ADA Compliance Program

Clark County Facilities Transition Plan Clark County Center for Community Health – 3rd and 4th Floors

Date of Survey: May 8, 2006

Item: Drinking Fountain – 3rd Floor Lobby

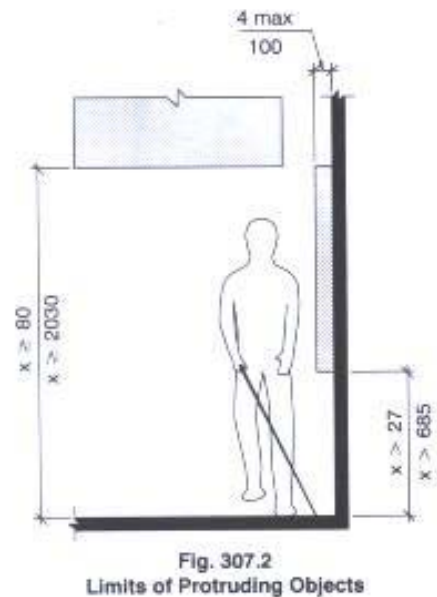
Typical installation of all drinking fountains on 3rd floor and throughout the building.

ANSI 307.2 Protrusion Limits.

Objects with leading edges more than 27 inches and not more than 80 inches above the floor shall protrude 4 inches maximum horizontally into the circulation path.

The drinking fountain shown protrudes 11 inches and the height shown is 32 3/8 inches.

- Fountains should be recessed into an alcove.
- Barrier's constructed around fountains
